**ADDENDUM NO. 1**

**CID 01-STILLHOUSE BRANCH WASTEWATER TREATMENT FACILITY  
IMPROVEMENTS**

**PROJECT NO.: 2-01590 | TWDB CWSRF NO. 73776**

**DATE OF ADDENDUM: MAY 24, 2023**

DATE	5-8-23	DESIGNED	J. JENKINS
		DRAFTED	M. CLOUGH
		CHECKED	J. JENKINS
		PROJECT NO.	2-01590
		DRAWING NO.	<b>P-01</b>

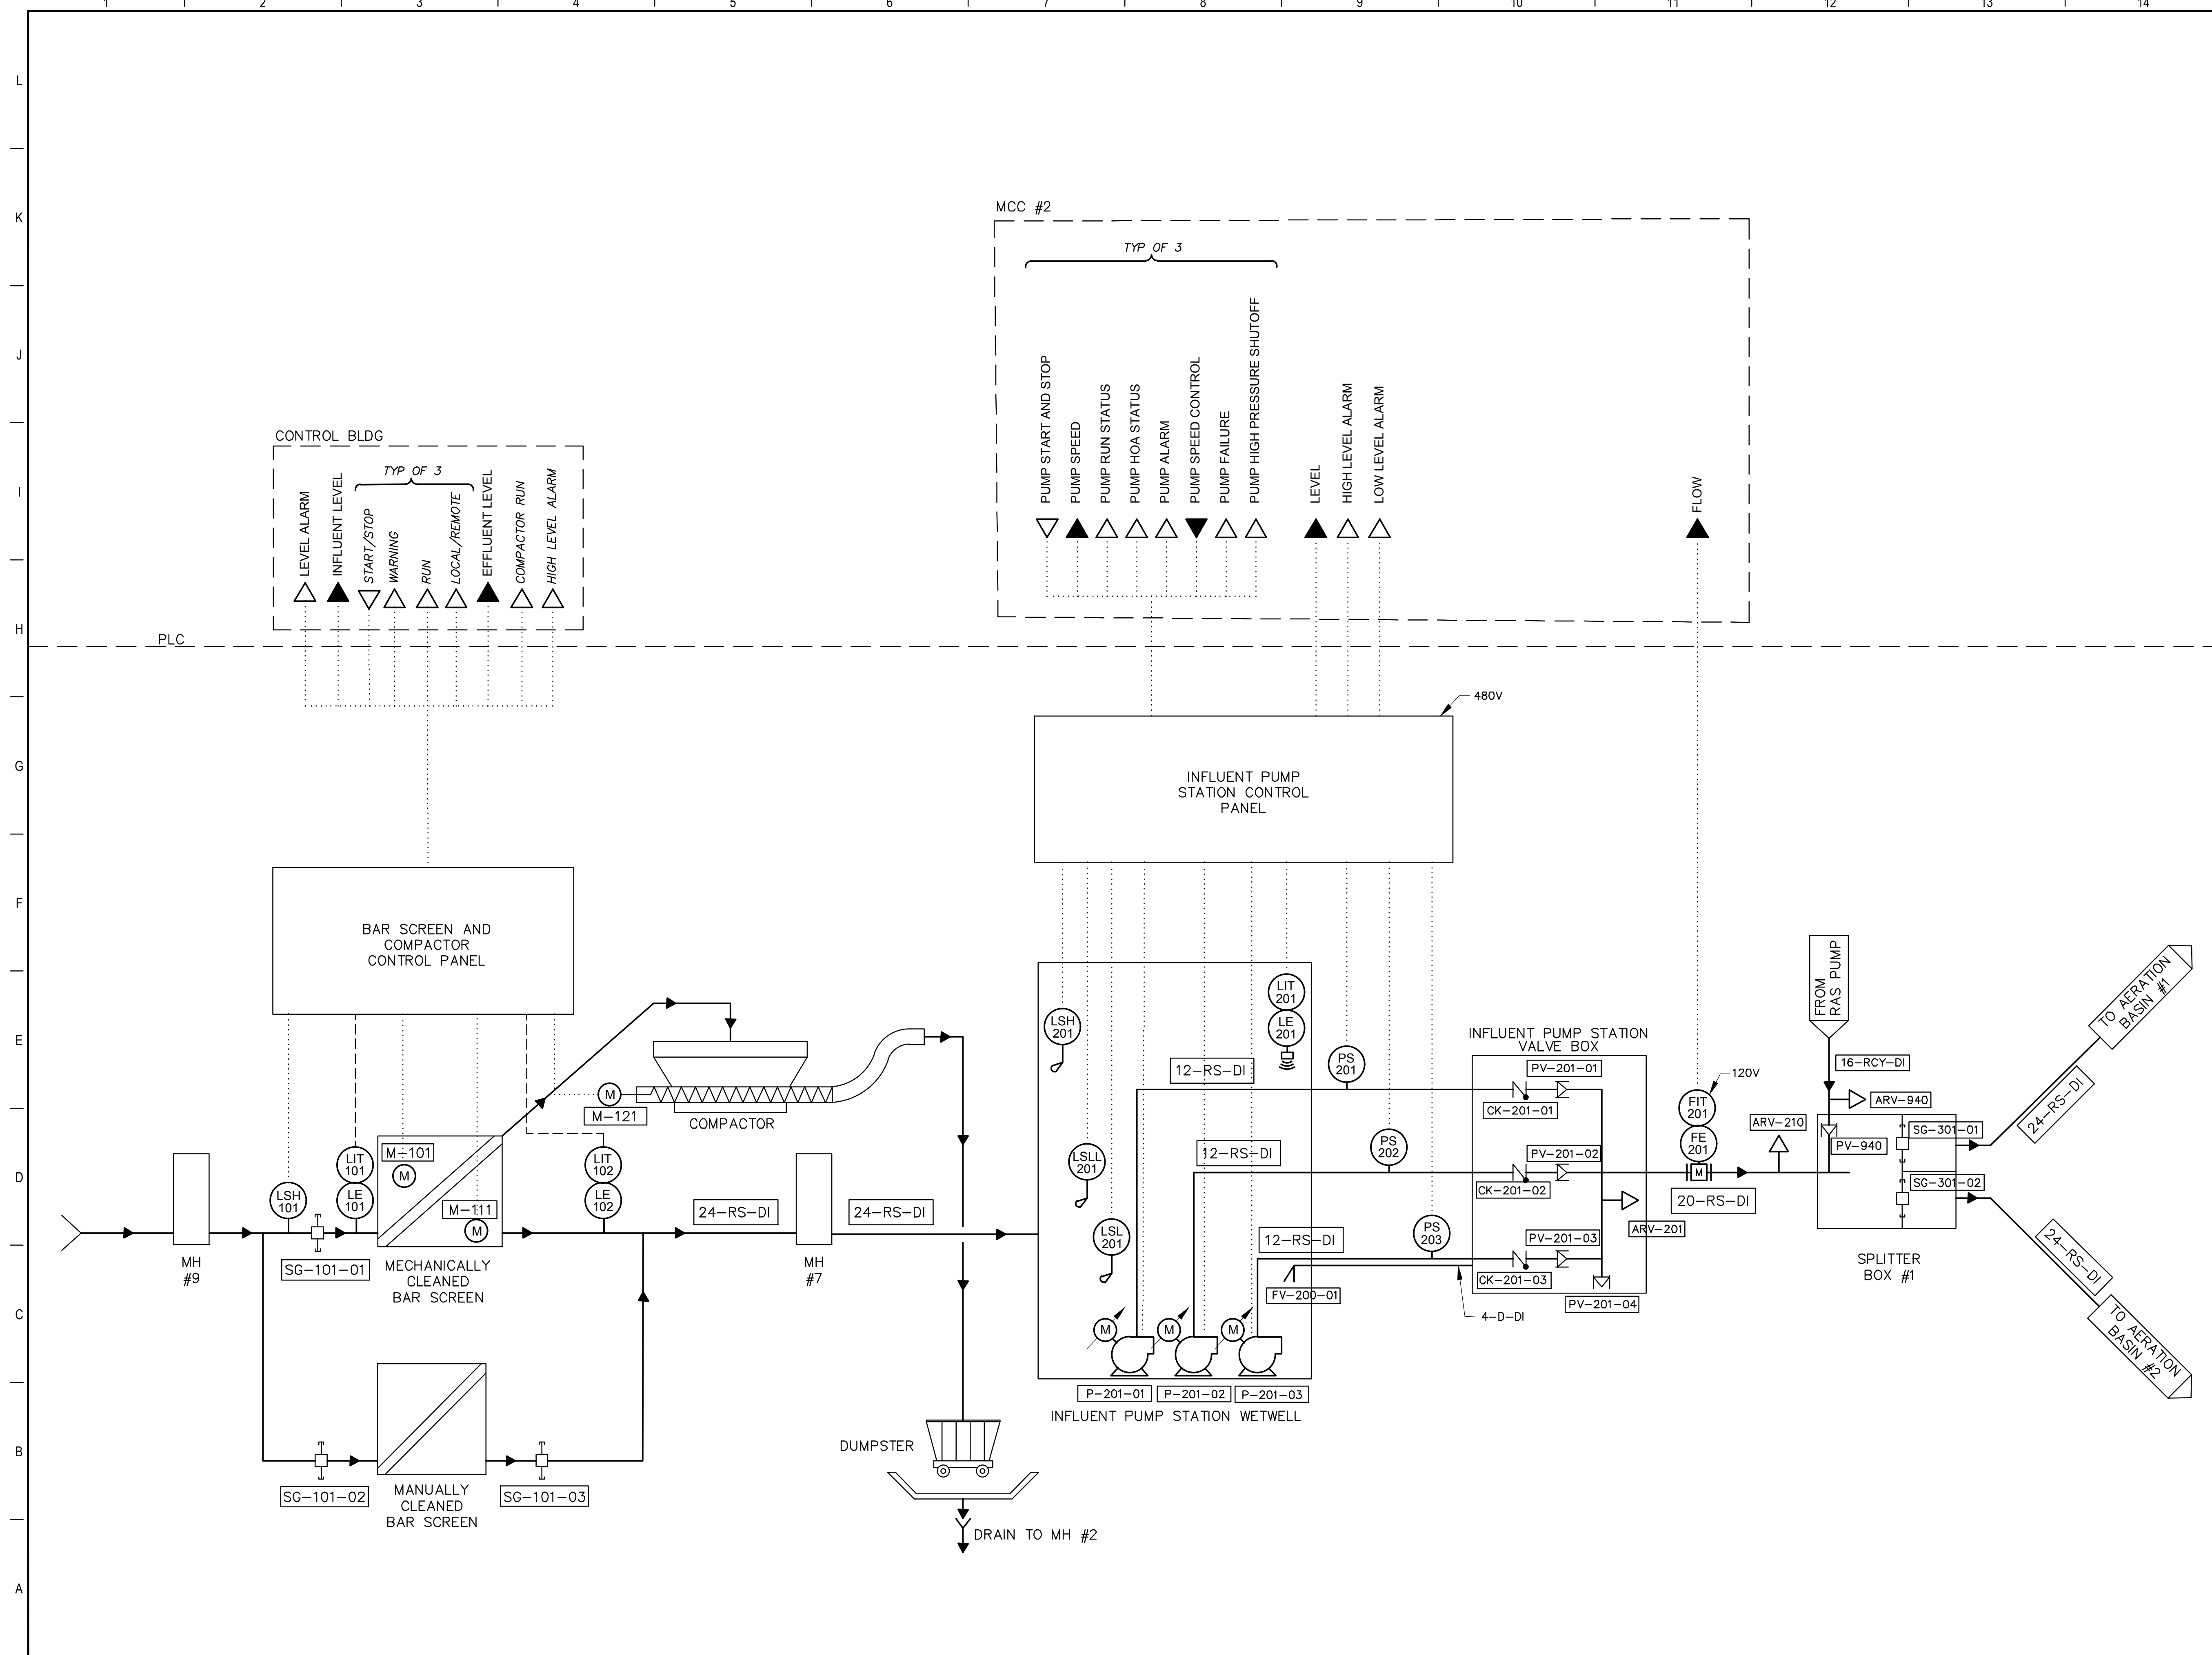
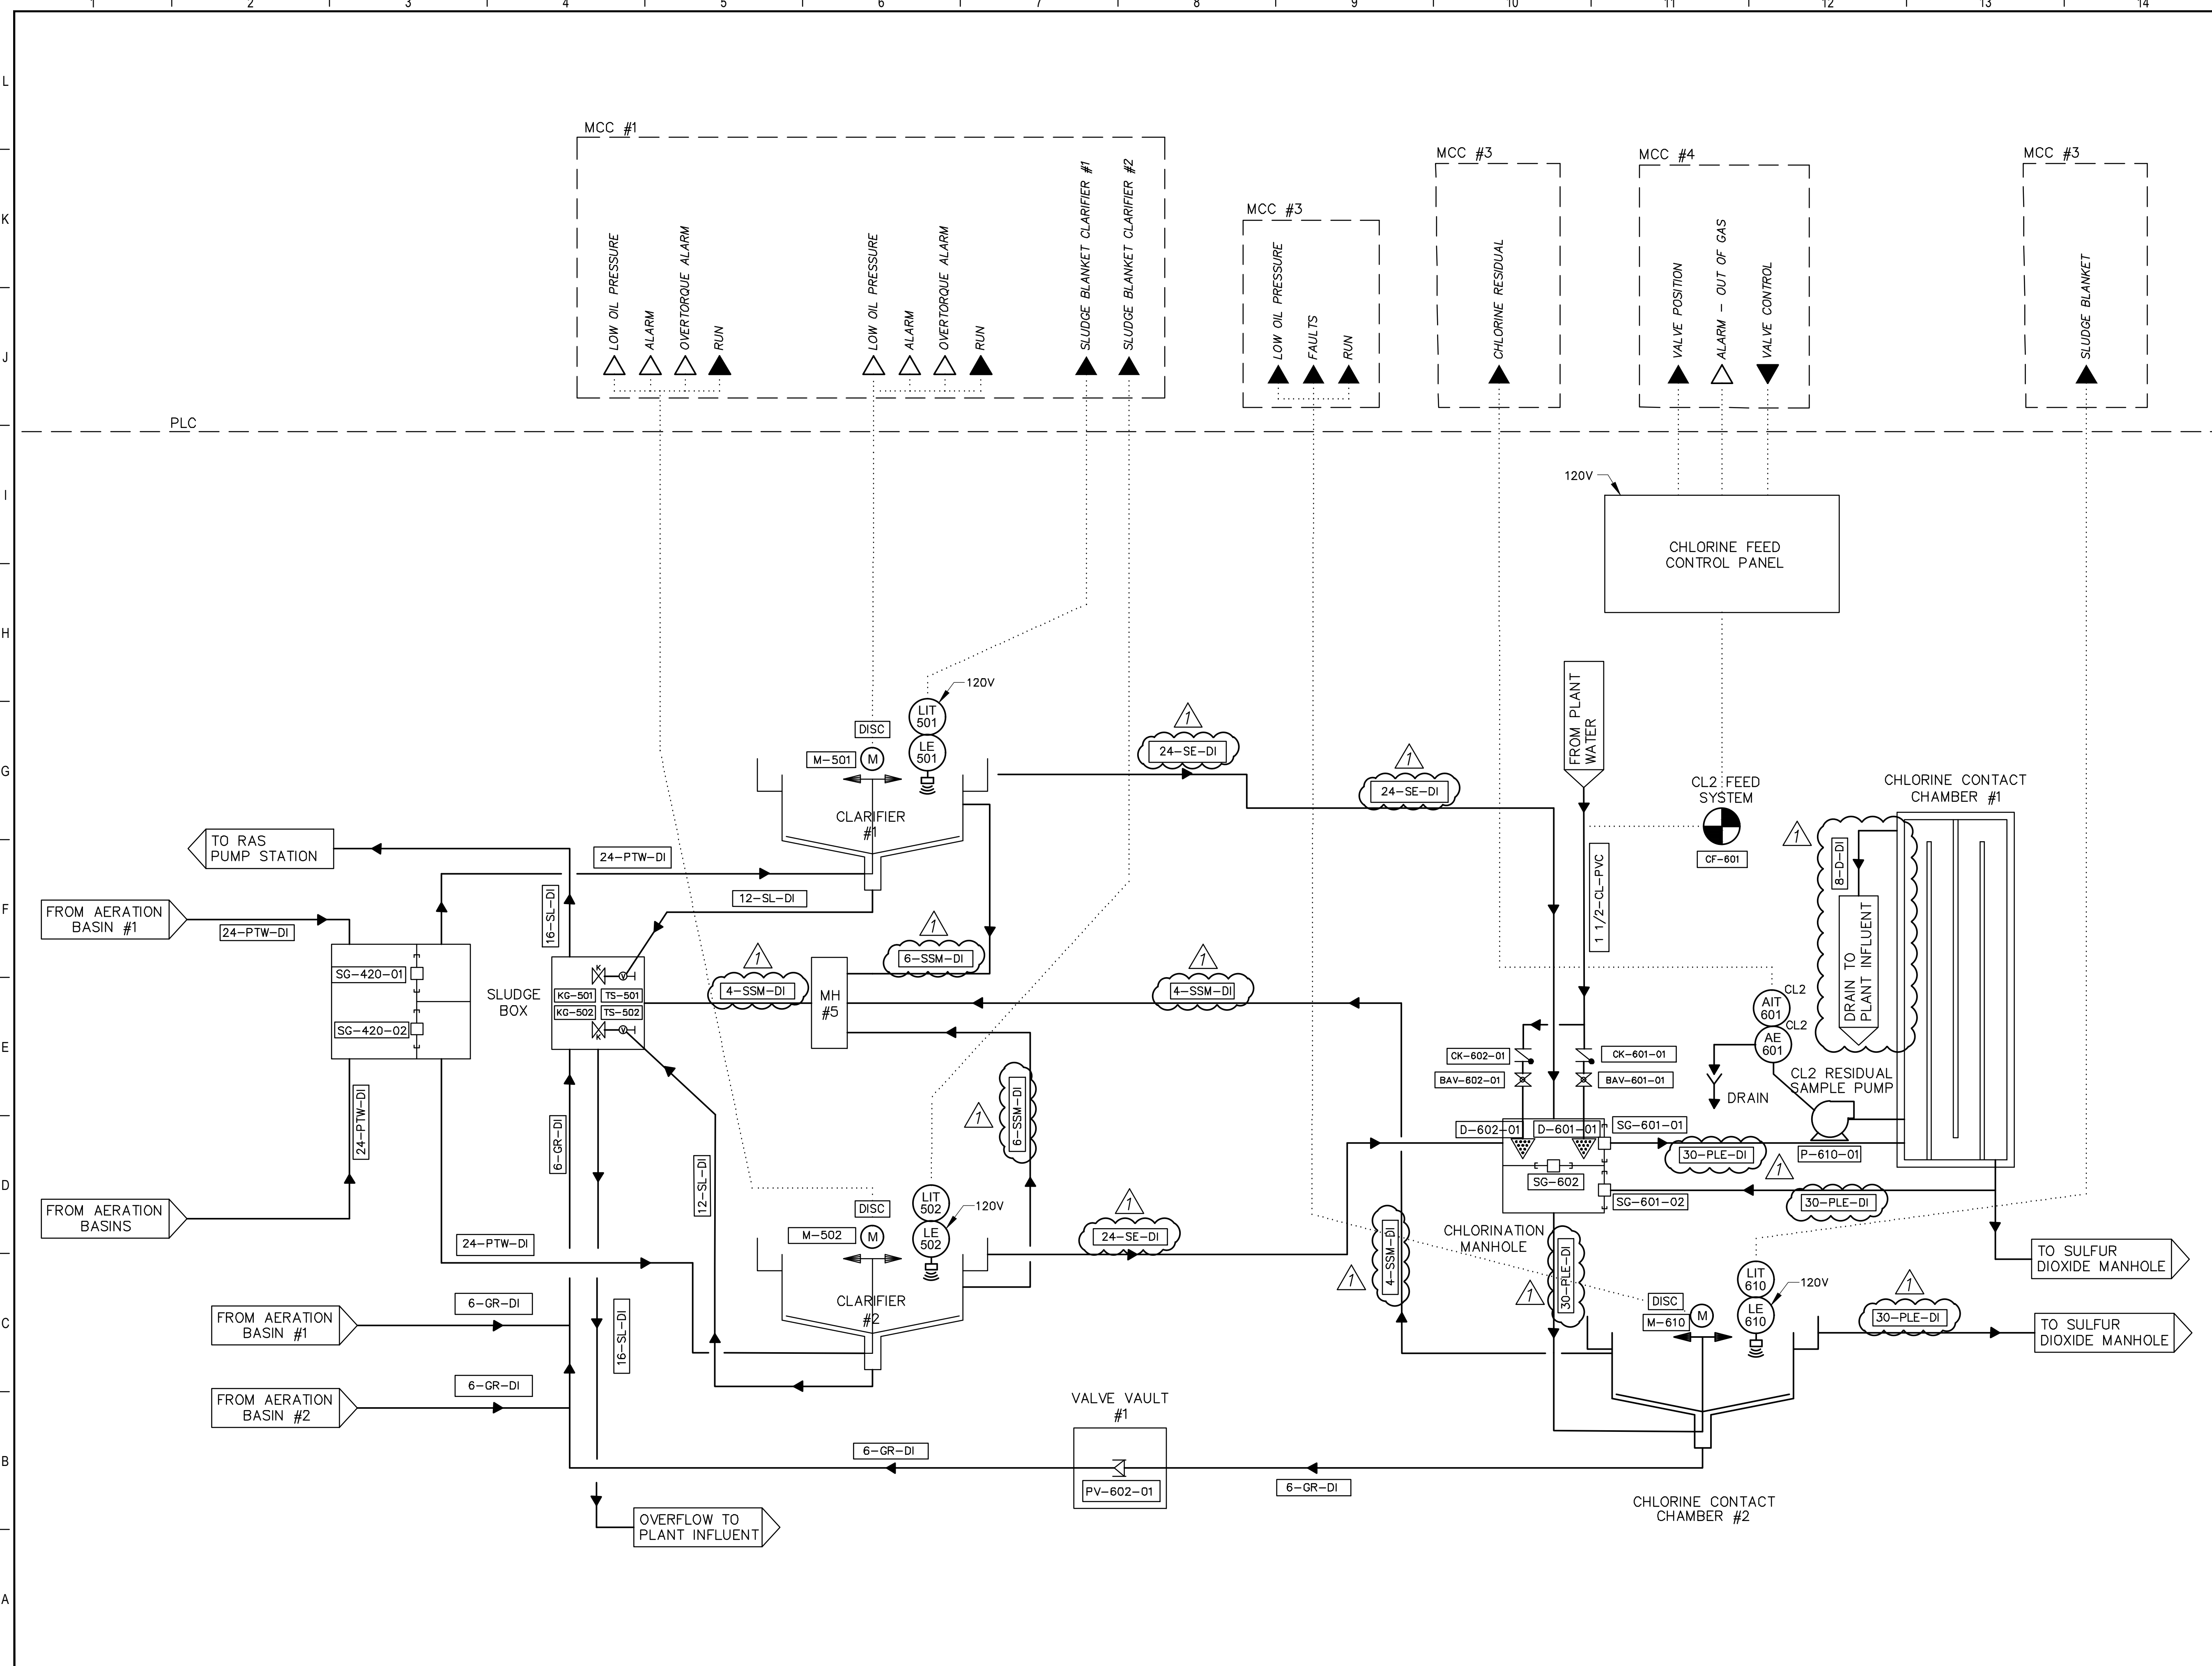
c. Sheets P-01 through P-05

REVISE to match the yard pipe labels.
